South Texas Project Electric Generating Station P.O. Box 289 Wadsworth, Texas 77483

December 21, 2010  
U7-C-STP-NRC-100274

South Texas Project  
Units 3 and 4  
Docket Nos. 52-012 and 52-013  
Supplemental Response to Request for Additional Information

RAI 03.07.01-27, Supplement 1

Figure 03.07.01-27.6 - 5% Damped Spectral Comparison in X Direction at Top of Roof Slab (Corner), El. 50.0 ft

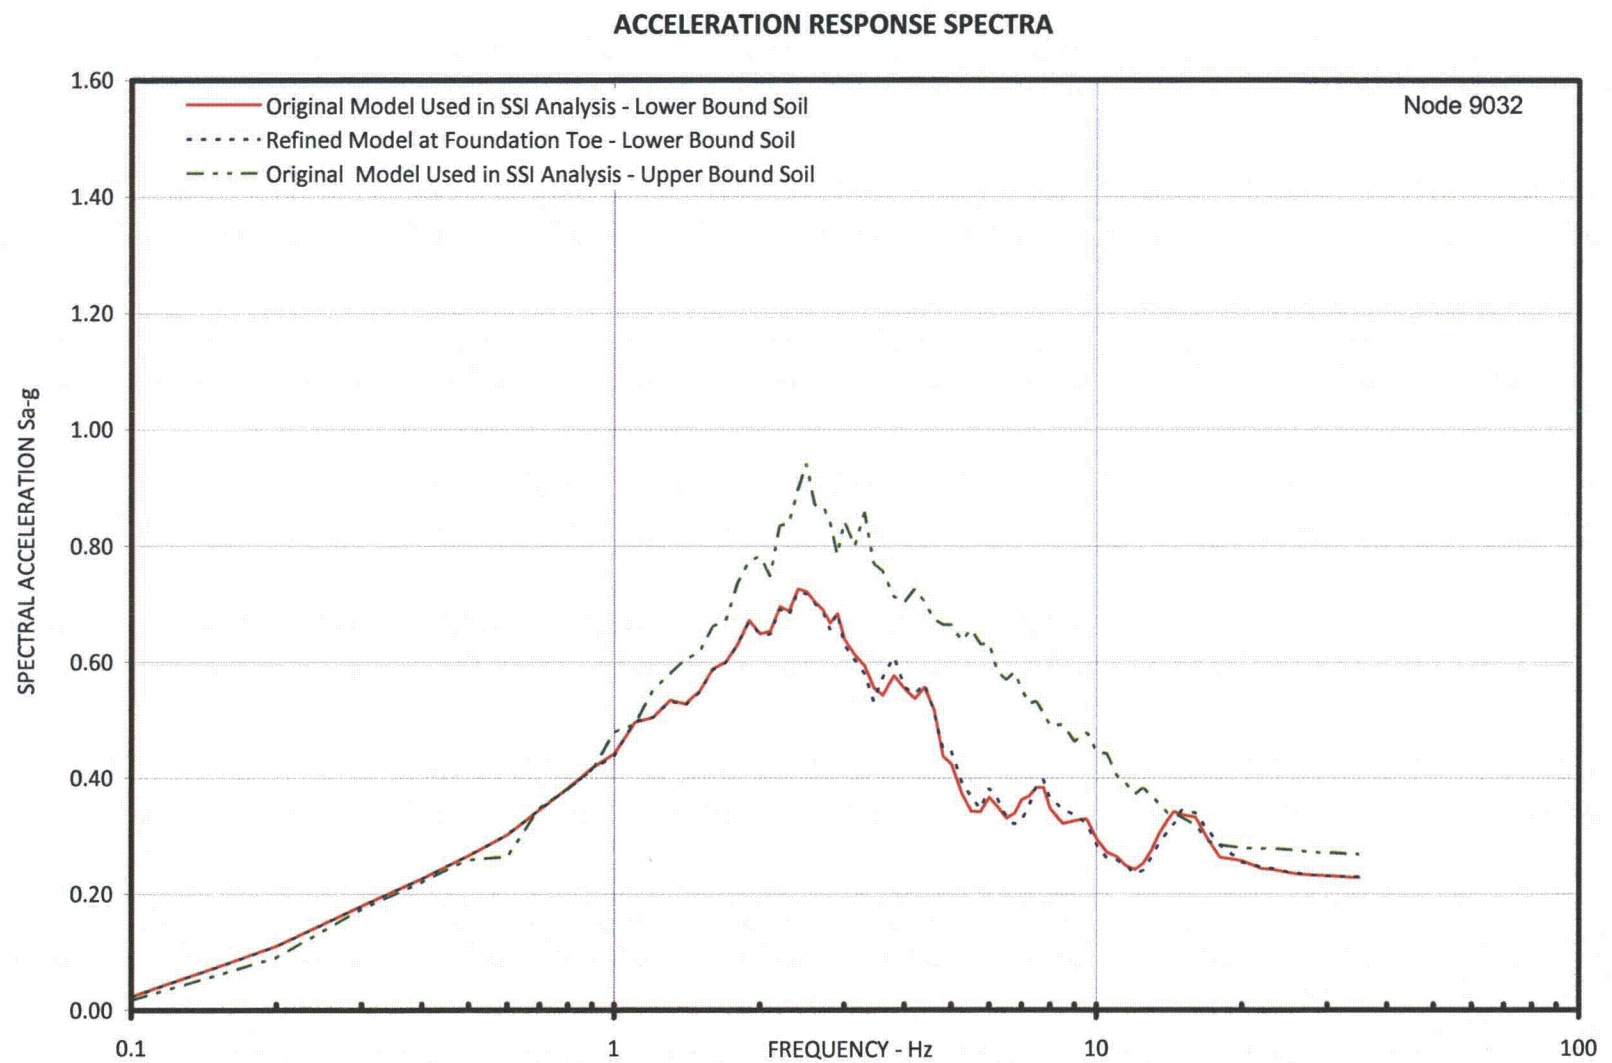
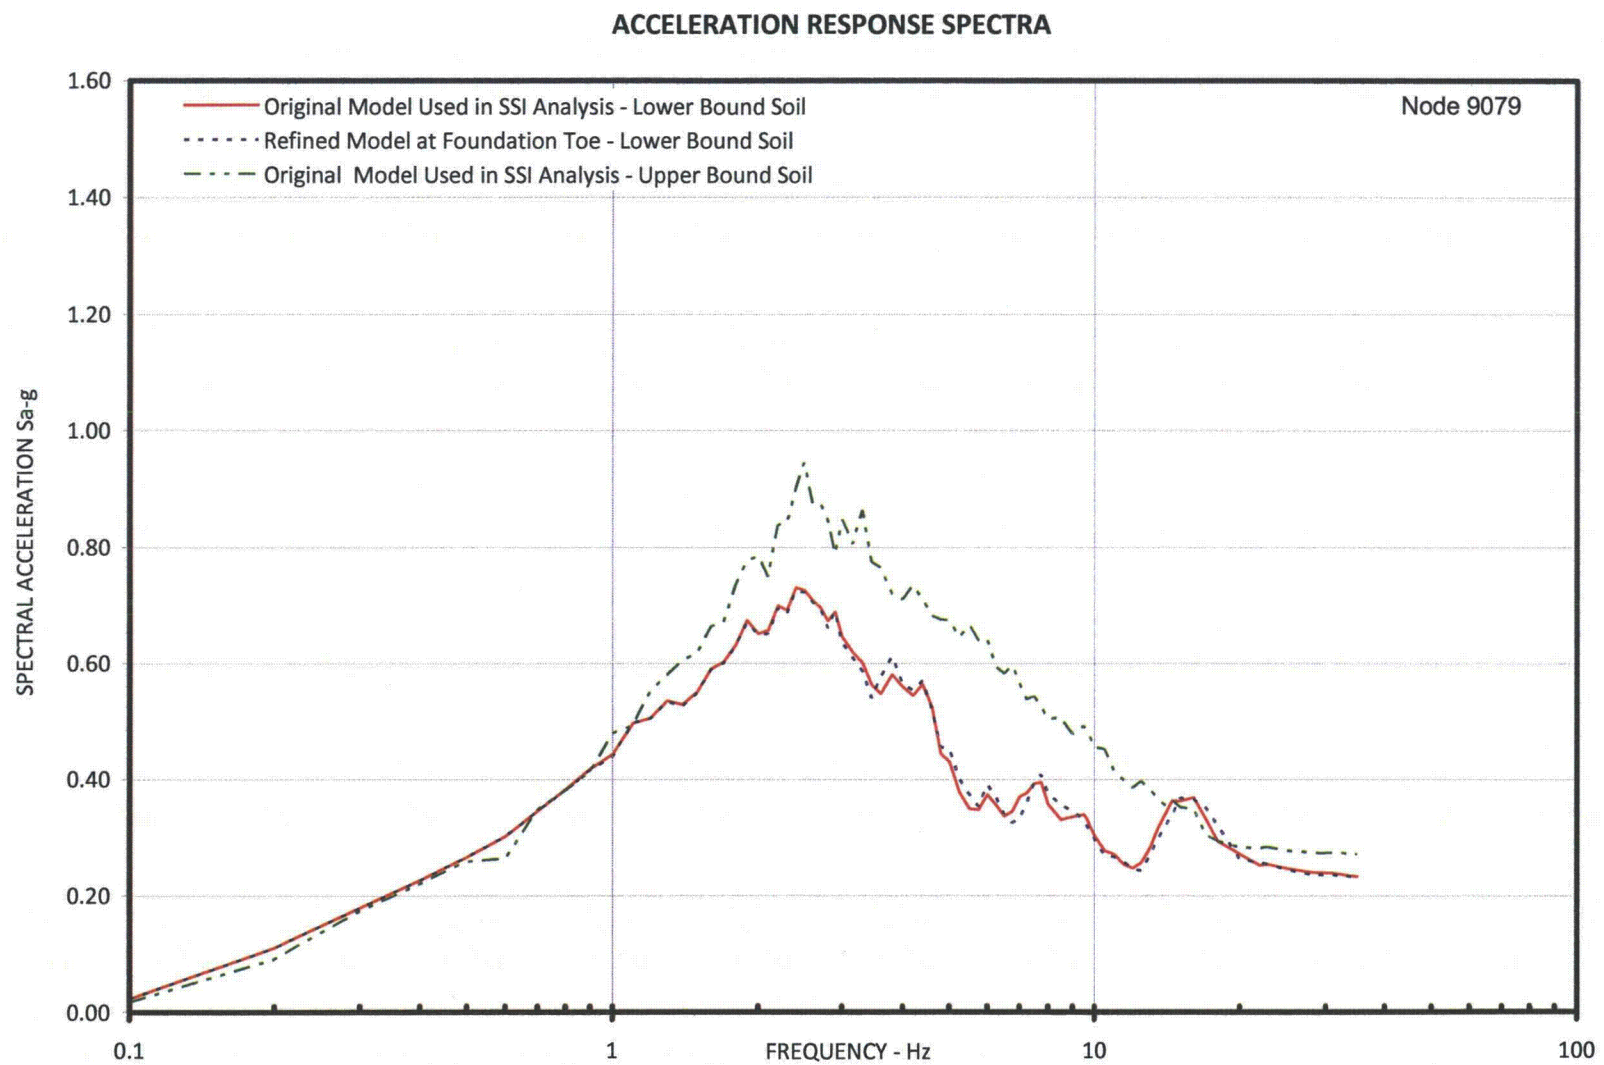
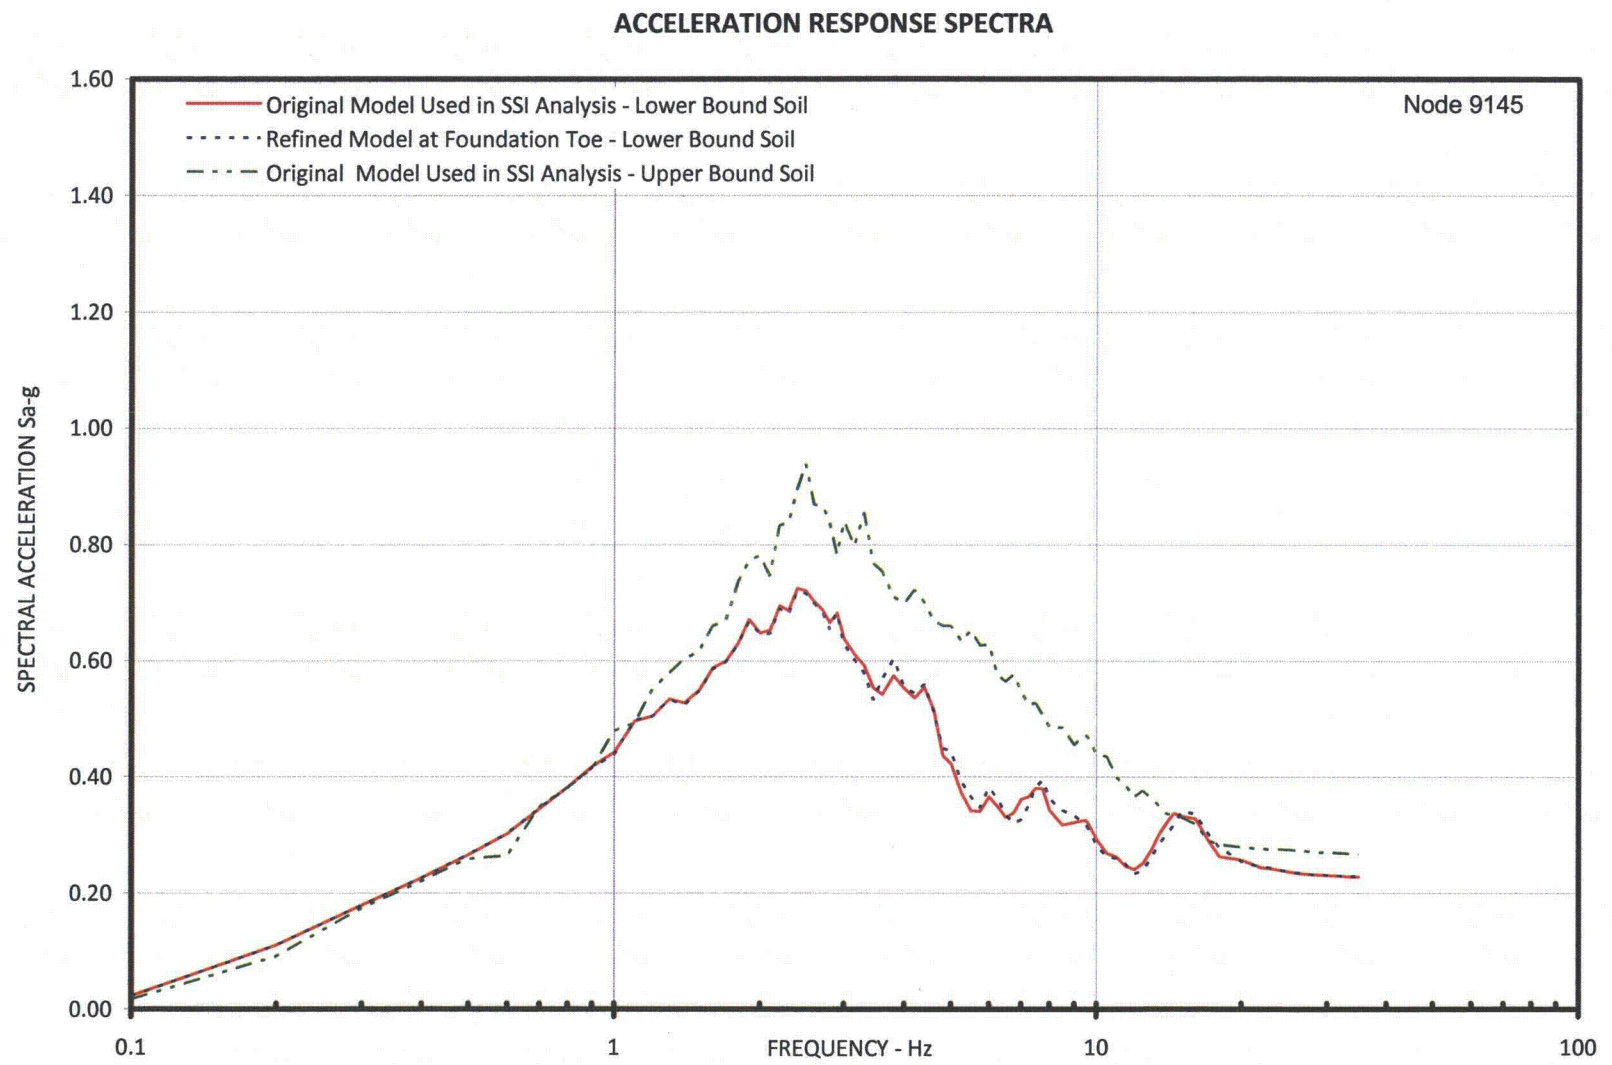
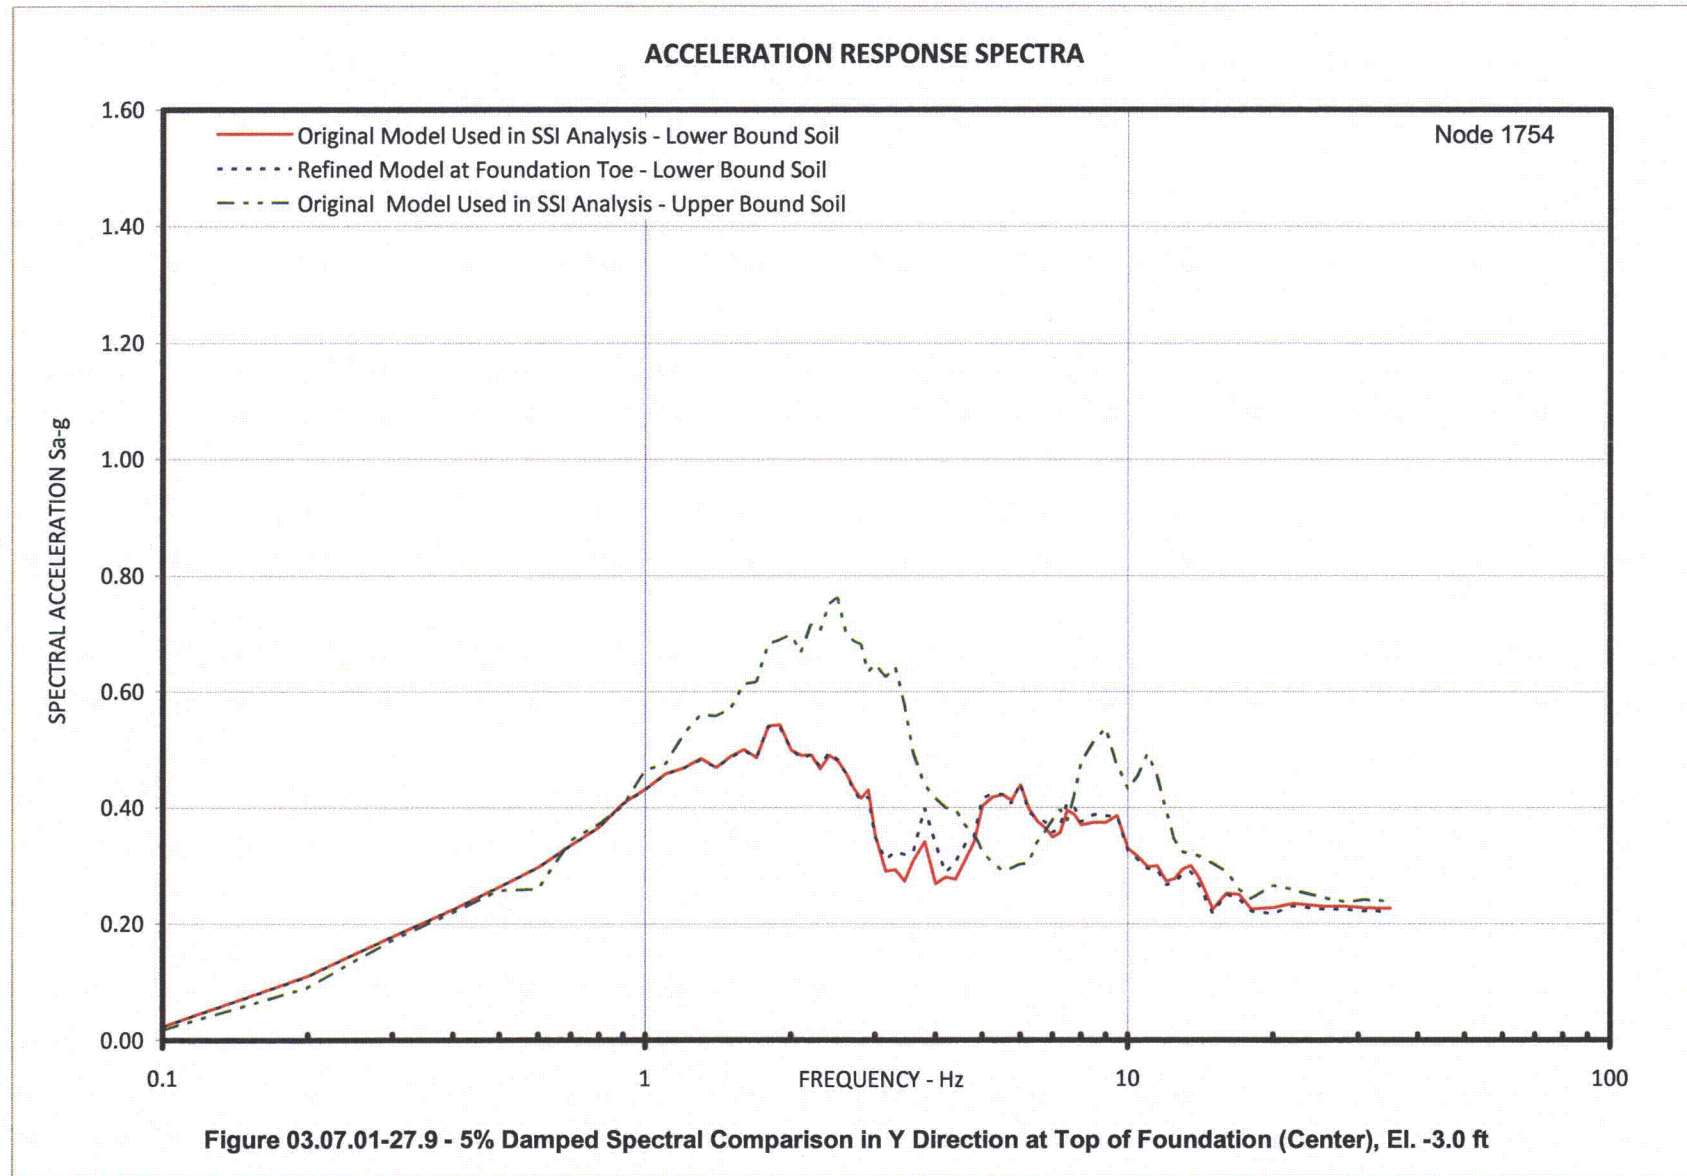
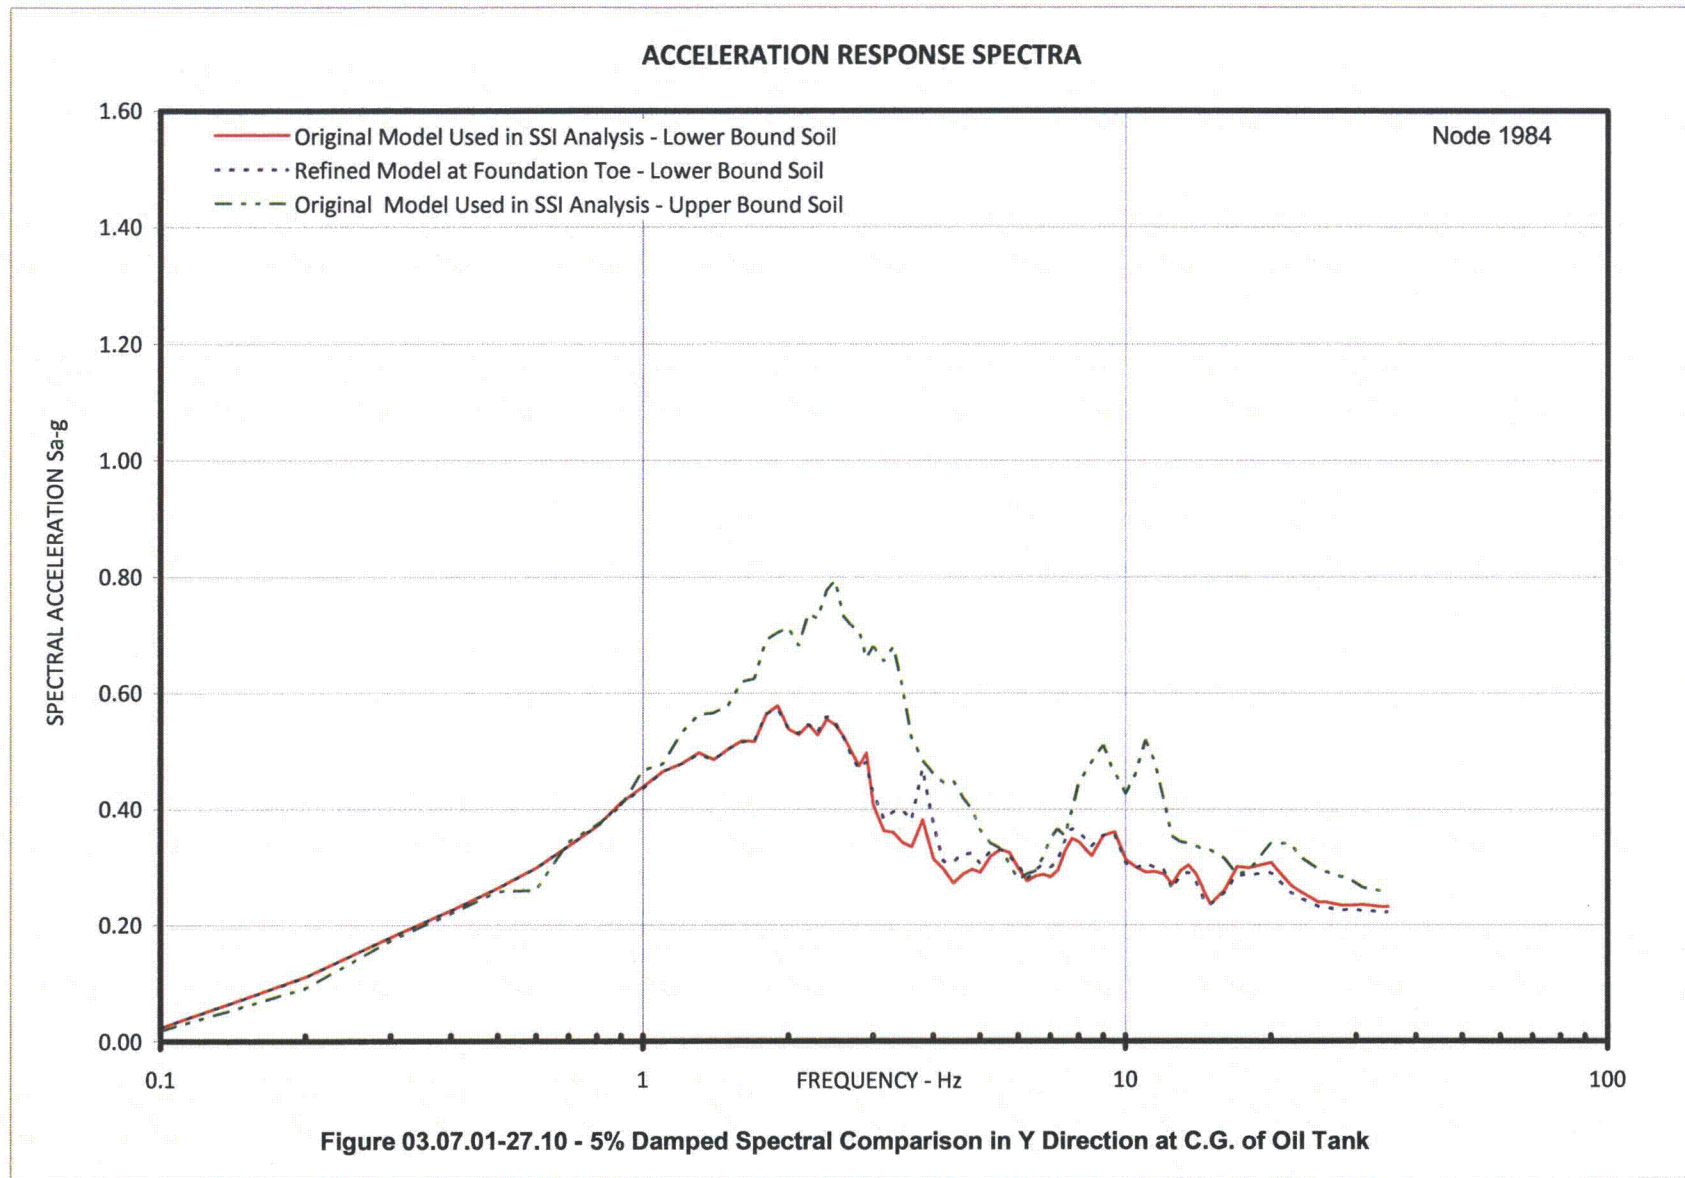
- (a) Describe in detail the method used for the SSI analysis of DGFOVS including the procedures for treatment of strain dependent backfill material properties in the model, input motion used and how it is specified in the analysis, variation of soil properties, and the computer programs used for SSI analysis.

To evaluate the effect of 20 Hz passing frequency for LB in-situ case, the foundation toe was divided into two elements, thus increasing the passing frequency to 40 Hz. This refined model with LB in-situ soil properties was analyzed and 5% damped spectra from this model were compared with the spectra from the original model with passing frequency of 20 Hz. The spectra comparison plots are shown in Figures 03.07.01-27.1 through 03.07.01-27.24. The comparison shows that:

- In the X direction, there is insignificant difference between the response spectra from the two models
- In the Y direction, the response spectra from the two models matched well except at frequency of about 3.8 Hz where the refined model produced higher spectra. However, spectra from both the models are enveloped by the spectra for UB in-situ soil case
- In the vertical direction, the spectra from the two models matched well (insignificant difference)

Based on the above evaluation it is concluded that the horizontal direction passing frequencies are acceptable.
